ADDENDUM No. 1

Project Name:	Owner: City of Dexter Project Name: Dexter City Hall Renovations	Addendum No: One (1)
Project Number:	21-113	Issue Date: January 21, 2022
Project Location:	3515 Broad St. Dexter, Michigan 48130

PARTNERS

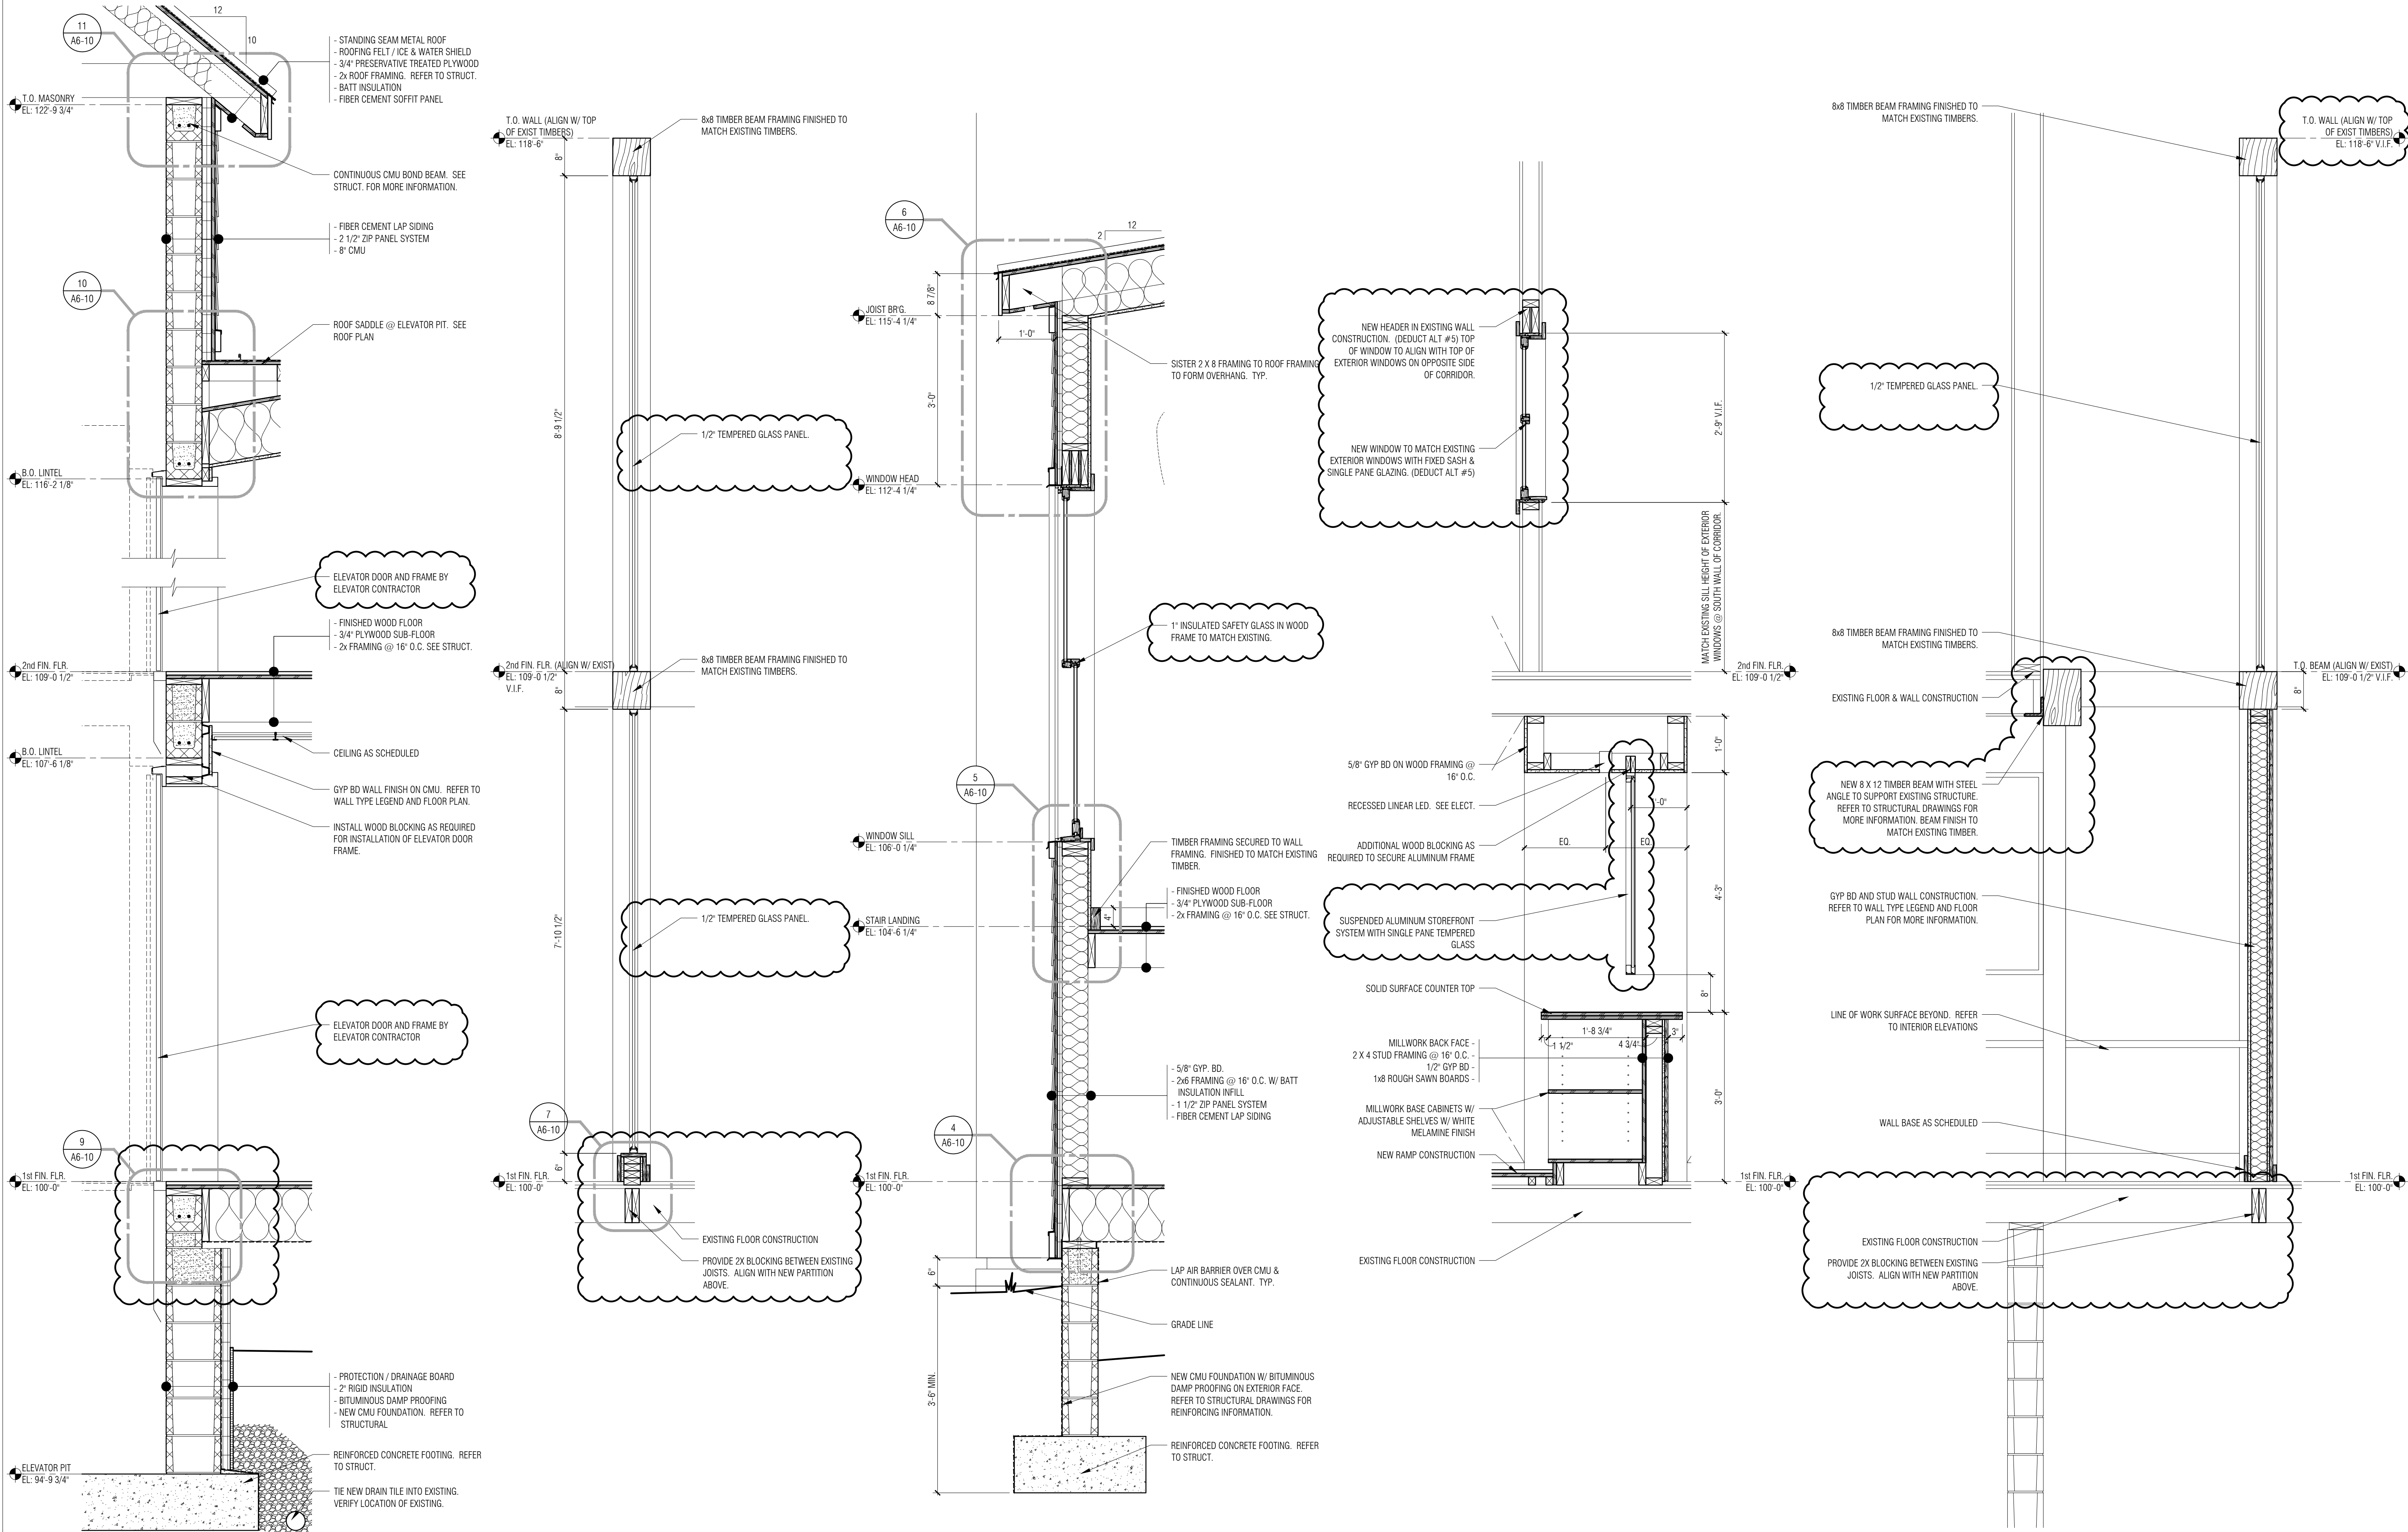
- ITEM A21** A5-10 Building Sections (Revised & Re-Issued)
- A. Filled out missing tag information on section 5.
 - B. Extended section 4 to show supported slab in front of vestibule.

- C. Updated note on section 3 to refer to deduct alternate #6, rather than add alternate # 3.
 - D. Removed door from section 2.
 - E. Now showing drain tile on both sides of elevator pit on section 2.

- F. Updated stair railing to show tension cable system, rather than vertical bars, on section 1.
 - G. Added detail of hoteling area per updated plan changes.
